10/529,874

Office Action Summary	Application No. 10/529,874	Applicant(s) DUWENDAG ET AL.	
	Examiner Christopher C. Caillouet	Art Unit 4191

GLUING DEVICE IN A BOTTOM LAYING DEVICE

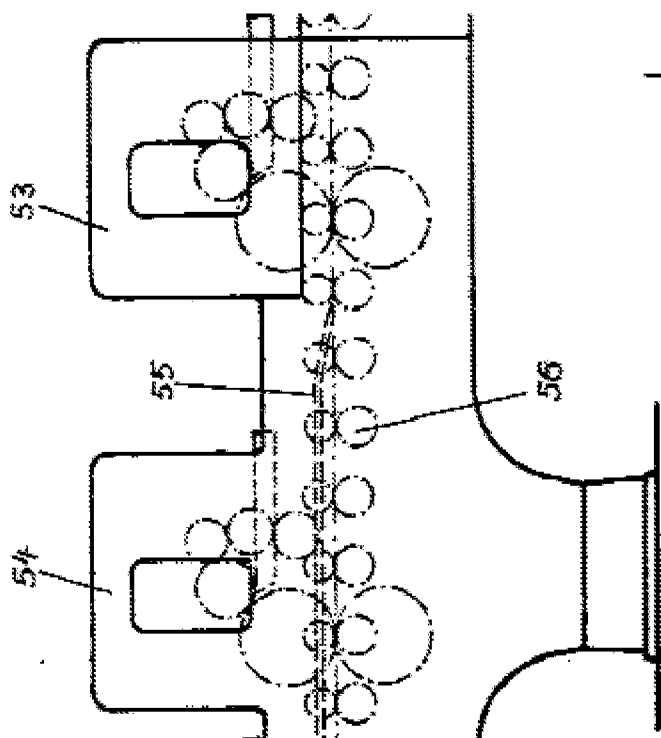
8. Claim 1 is rejected under 35 U.S.C. 103(a) as being unpatentable over the admitted prior art (APA) in view of Niemeyer (US Patent 3, 043,199).

Regarding claim 1, the admitted prior art discloses a bottoming device having different processing stations, glue transfer rollers and counterpressure rollers whereby

during transport the axis of the tube is as claimed and during gluing the folded bottom lies orthogonal to the tube axis (page 1 and Figs 1-2). However, the APA does not teach to offset the gluing stations in the direction of the transport axis.

Niemeyer teaches an apparatus for forming cross bottomed-valve bags from tube segments whereby the tube segments pass through different processing stations, forming cross bottoms at both ends. (Column 4 lines 58-70). Niemeyer recognizes the problem where the bags are so short in relation to their width that the gluing portion cannot be performed on the ends of the blank simultaneously (column 1, lines 21-32). Niemeyer further teaches to offset the gluing stations for the cross-bottom bag in the direction of conveyance (column 4, lines 6-19; Fig. 12 & 13), and the gluing application of the ends follows each other immediately. By offsetting the gluing stations, Niemeyer gains an advantage by being able to shorten the length of the machine, and that corresponding operations on the two ends of each blank are not separated from one another by means for performing other operations, but follow each other immediately (column 2, lines 35-41). Therefore, it would have been obvious for one of ordinary skill in the art at the time of the invention to incorporate mutually offsetting gluing rollers onto the admitted prior art, because Niemeyer teaches the use of such station configuration to make compact machine.

With respect to claim 2, in APA figures 1 and 2, the mean bottom size corresponds to the sum of the diameter of the counterpressure rollers (Specification page 4). Thus if this same prior art device was used for smaller bags (smaller mean bottom size), therefore, it would have been obvious to one of ordinary skill in the art to recognize the mean bottom size would have to be less than the sum of the diameter of the counterpressure rollers, i.e., the diameter of each of the counter pressure rollers is greater than half the mean bottom size.
